Enclosure
L-19-168

Summary of Changes

Perry Nuclear Power Plant EP 0000 Revision 53 Change Summary

REVISION: 53 EFFECTIVE DATE: 6-18-19

FIGURE 5-1 - EMERGENCY RESPONSE ORGANIZATION (INTERIM PHASE)

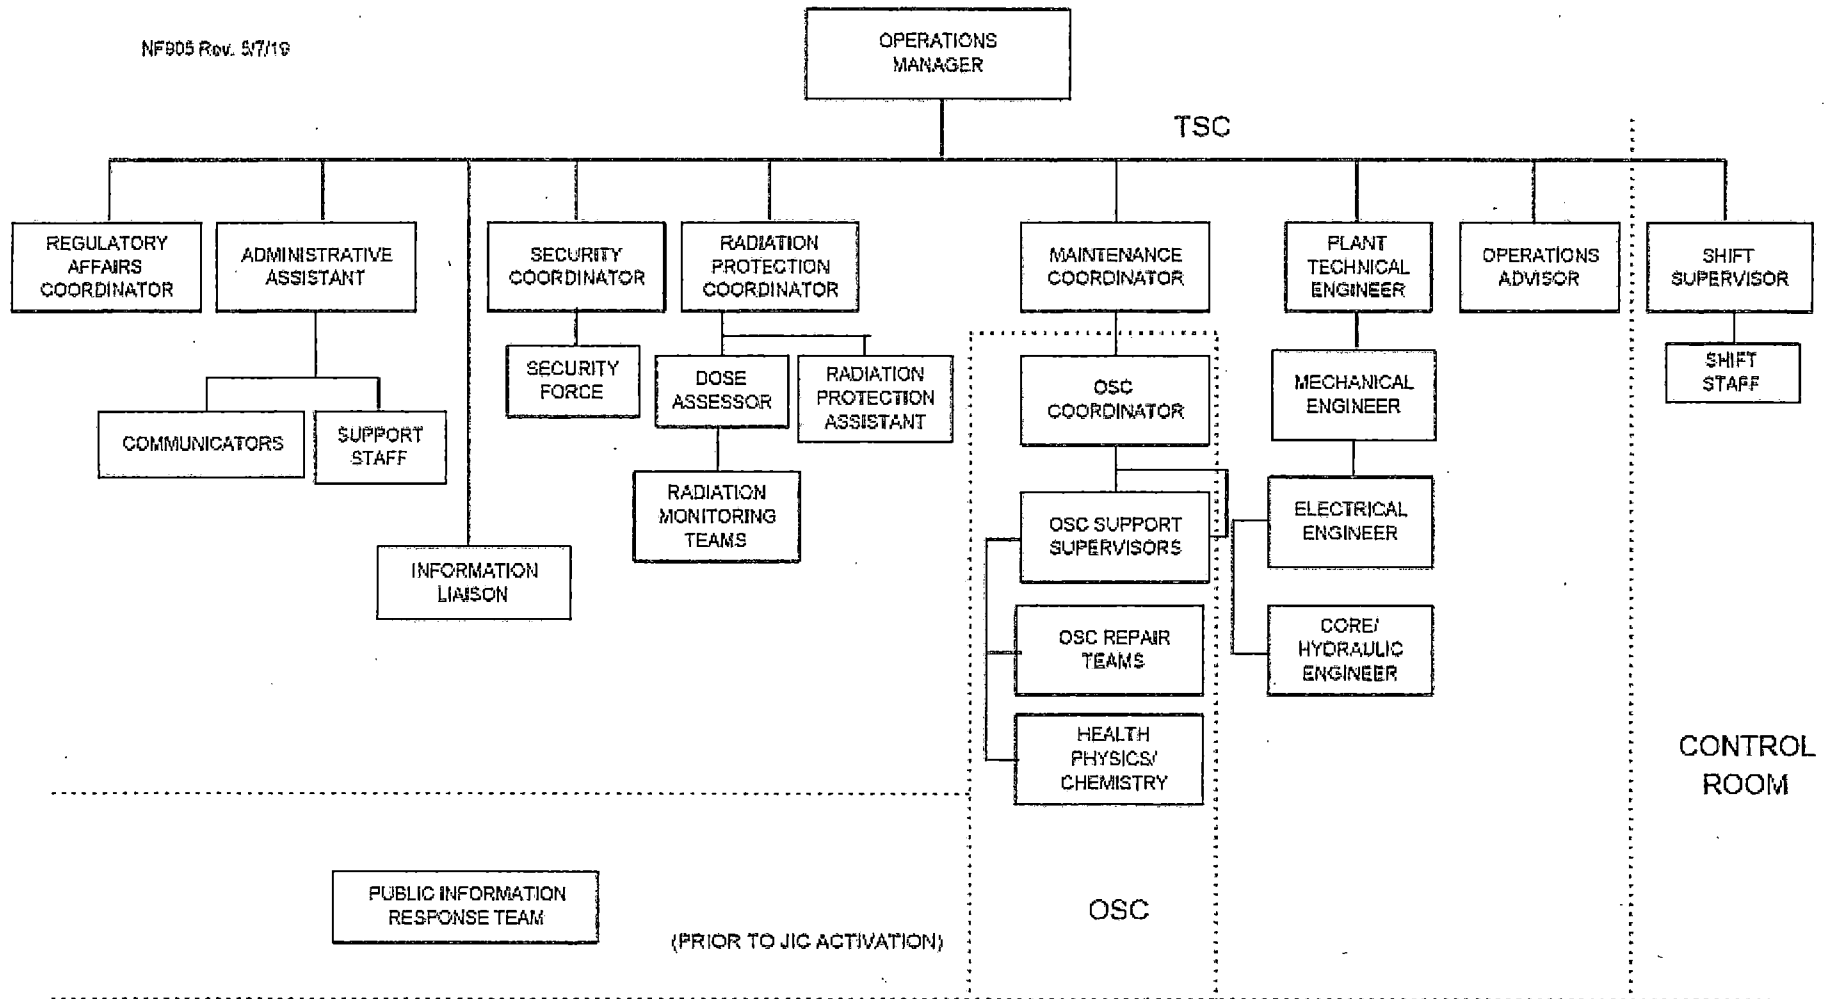
- a. Removed PIRT from Figure 7-4 to allow PIRT to be located at a location other than the EOF.
 - b. Removed EOF from Figures 5-1 and 5-2 to allow PIRT to be located at a location other than the EOF.

4. Removed Technical Engineering Staff from figures 5-1, 5-2 and 6-1 since the position is not required in staffing Tables 5-1a and 5-1b.
 - a. This position has no programmatic description in the Emergency Plan.

5. Removed Operations Liaison, System Analysis Engineer and Emergency Response Information System (ERIS) Operator from Figures 5-1 and 5-2 since the positions are not required in staffing Tables 5-1a and 5-1b.
 - a. These positions have no programmatic description in the Emergency Plan.

12. Removed PIRT from Figure 7-4 to allow PIRT to be located at a location other than the EOF.
 13. Removed EOF from Figures 5-1 and 5-2 to allow PIRT to be located at a location other than the EOF.

FIGURE 5-2 - EMERGENCY RESPONSE ORGANIZATION (FINAL PHASE)

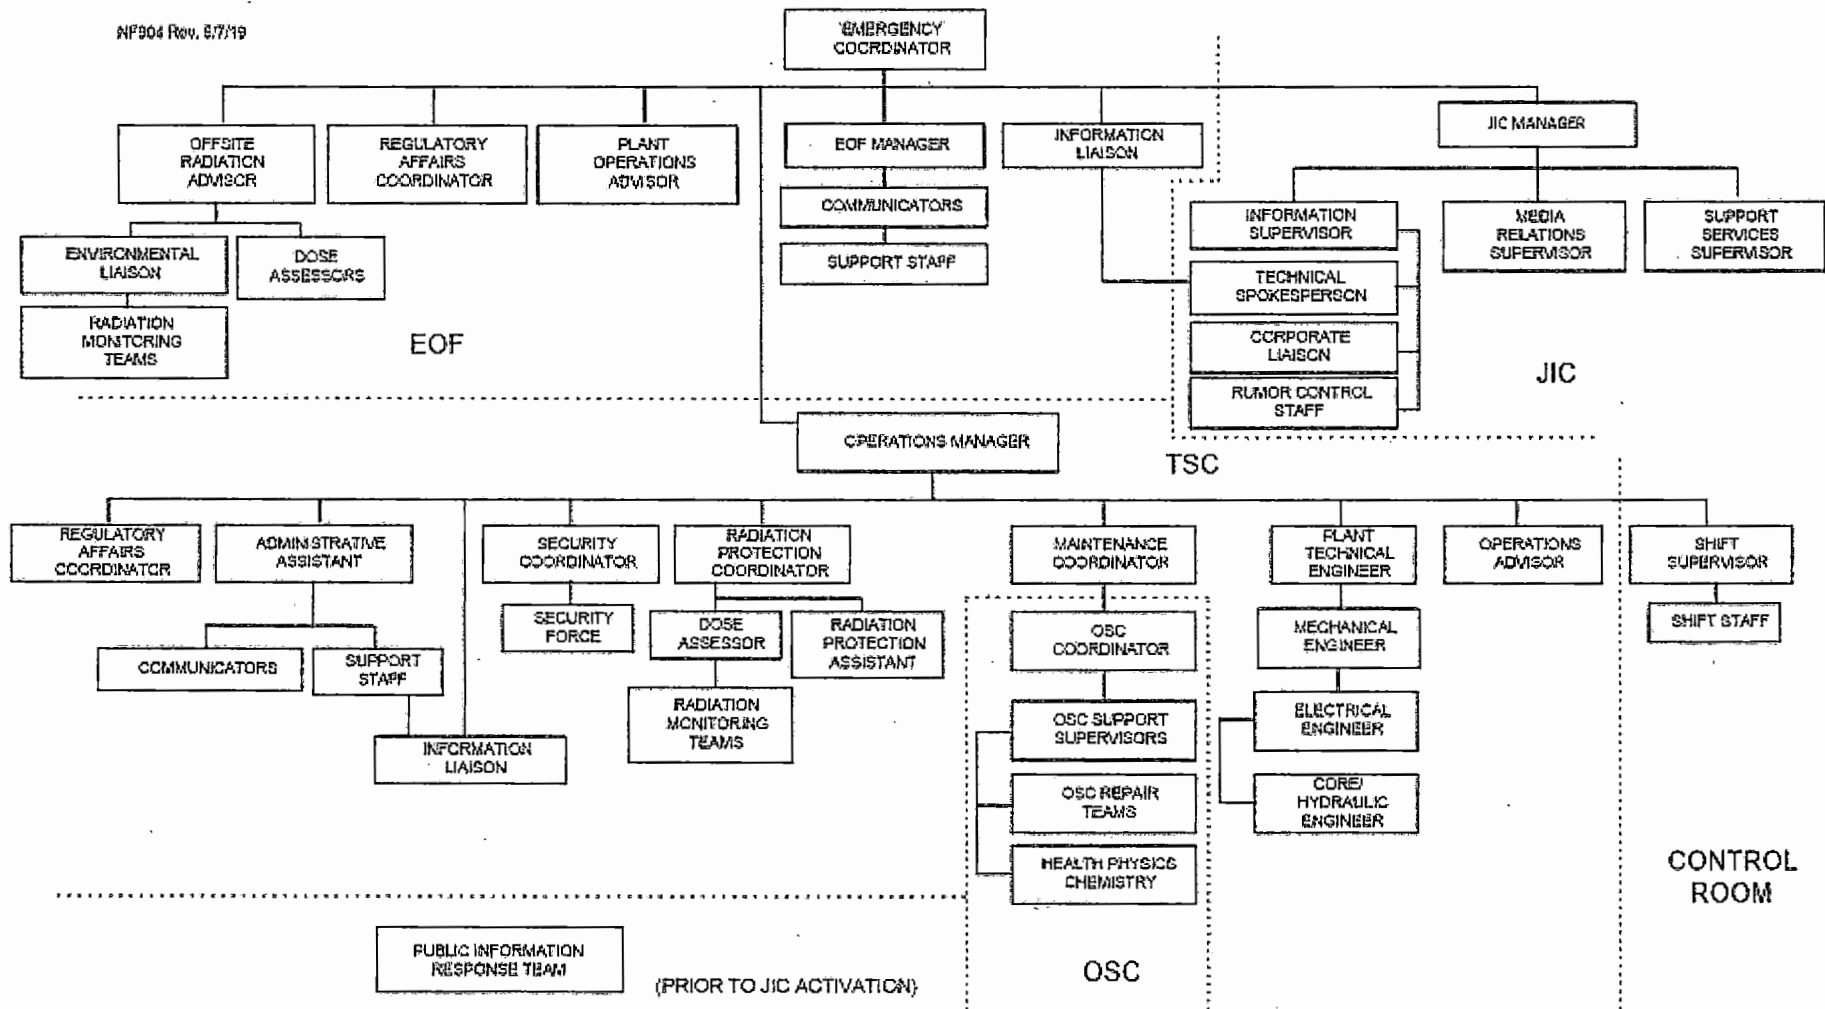
8. Eliminate the need for EOF Operation Assistant on pg. 5-11, due to advanced technologies.
 9. Removed the Operations Assistant from Figure 5-2 to match the text change.

FIGURE 6-1 - EMERGENCY NOTIFICATION

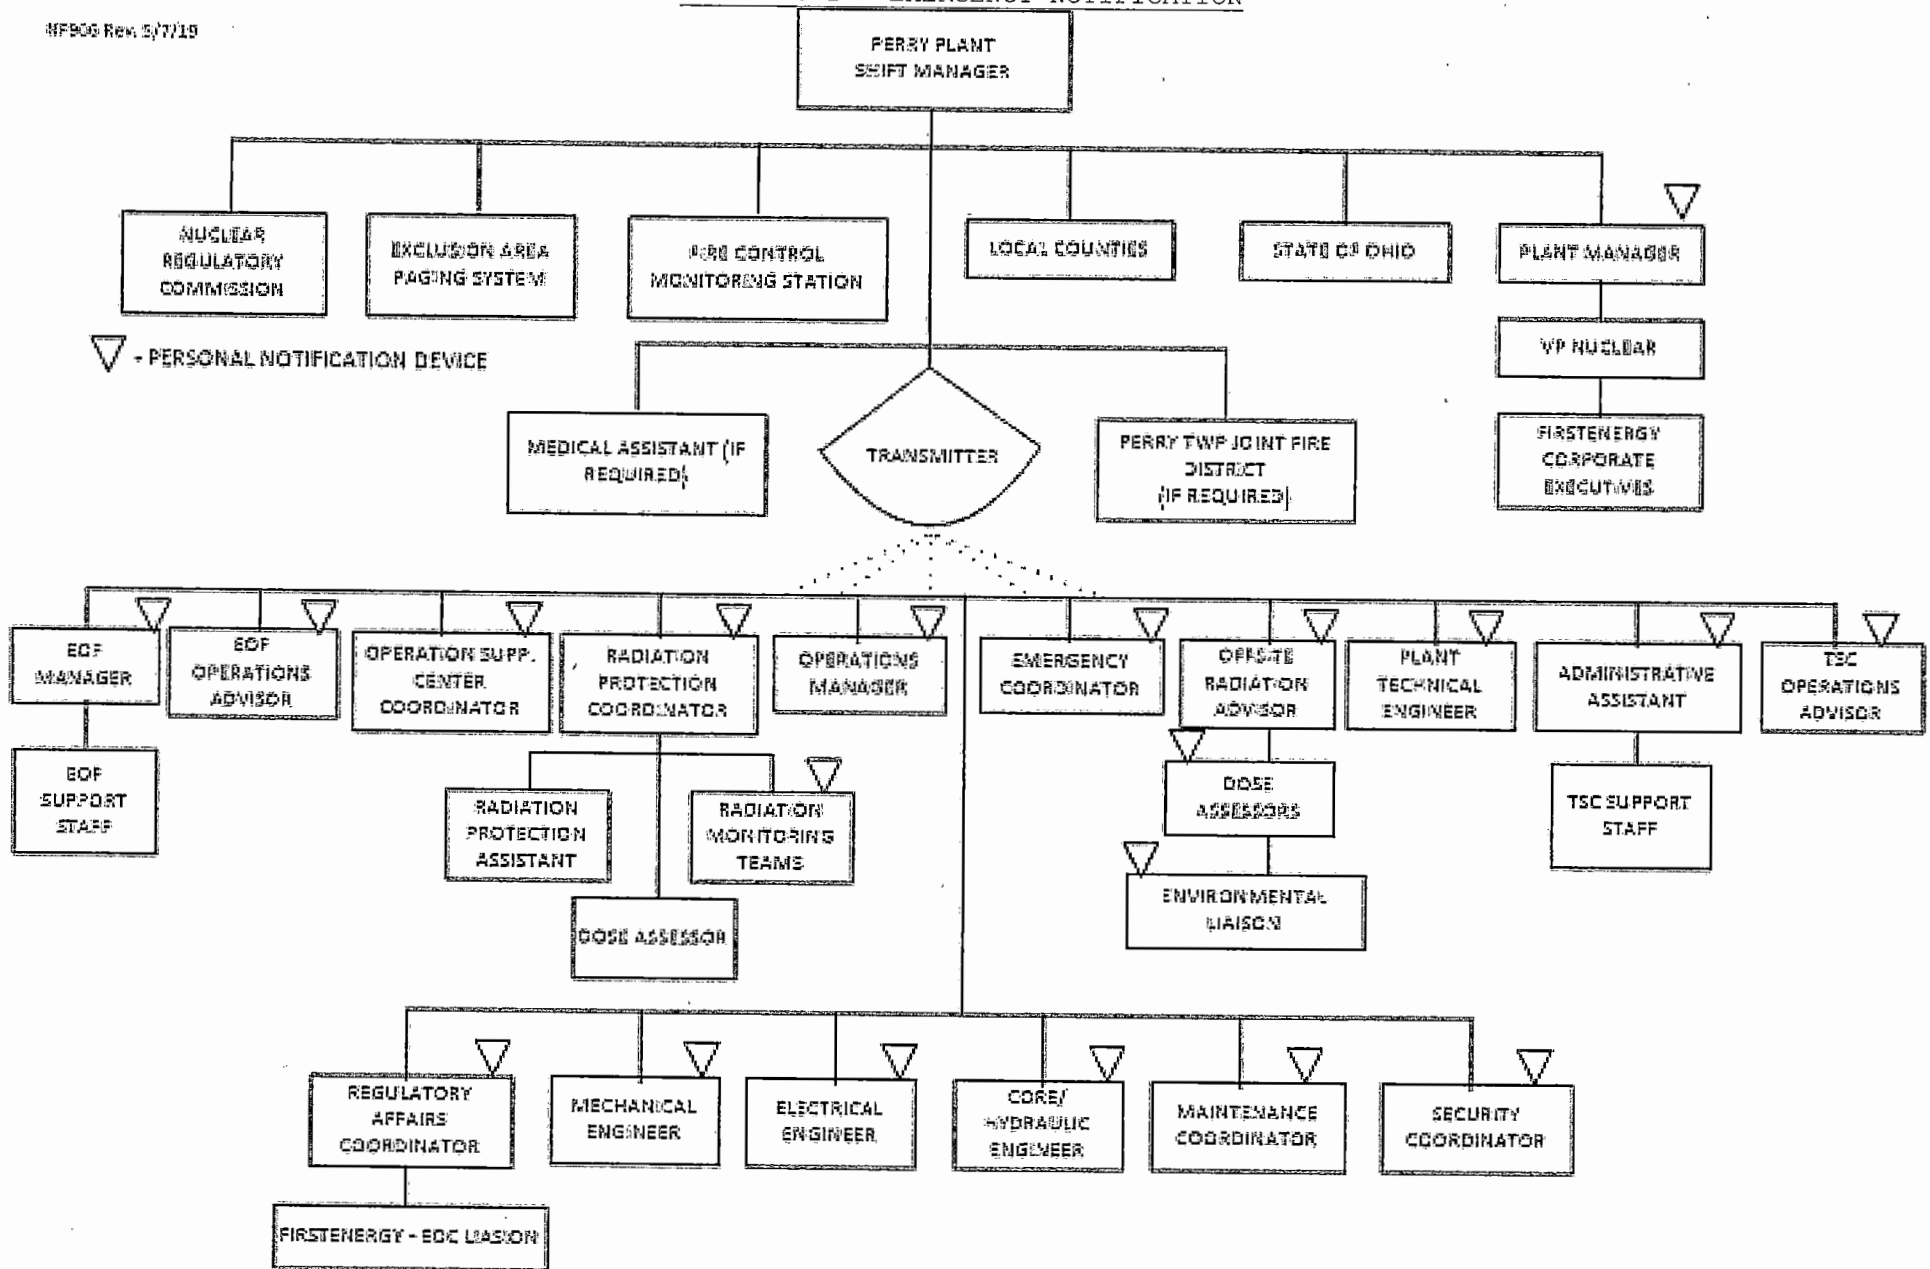
10. Removed the Operations Assistant from Figure 6-1 to match the text change.
 11. Removed "functioning from the EOF" and reworded in last sentence in 3rd paragraph for bottom of page 5-3 to allow PIRT to be function at any location prior to the activation of the JIC.
